Subcommittee 318B | Ballot Title: CB16-01

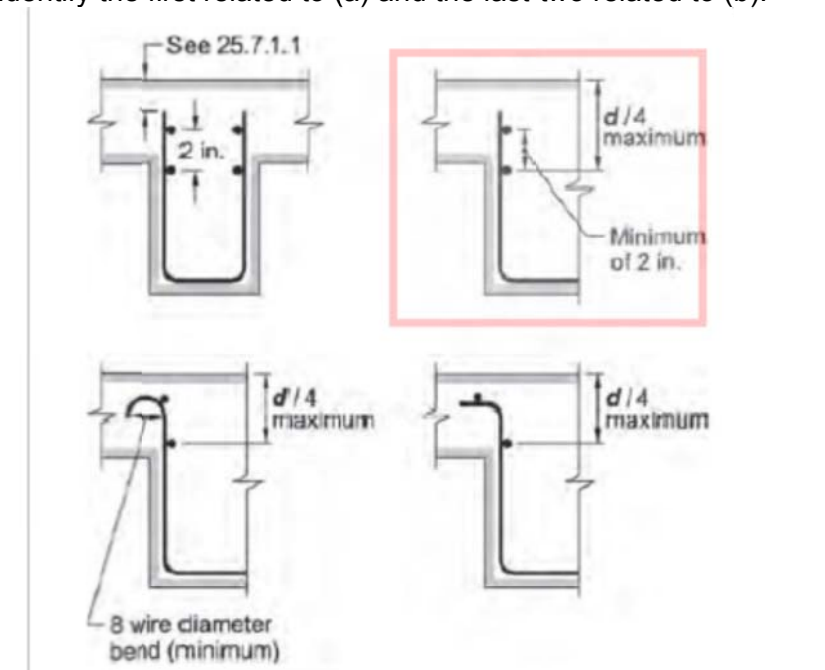
No.	Last Name	Item #	Line #	A/C or N	Comment
46.	French	CB600		Y	
47.	Jirsa	CB600		A	
48.	McGlohn	CB600		A/C	<p>I affirm this item but in an unrelated comment, what is the purpose of the 3rd figure in red box below? This figure seems like a version of 25.7.1.4 (b) that is not needed when the two lower figures appropriately describe 25.7.1.4 (b). I would take this figure out and identify the first related to (a) and the last two related to (b).</p>
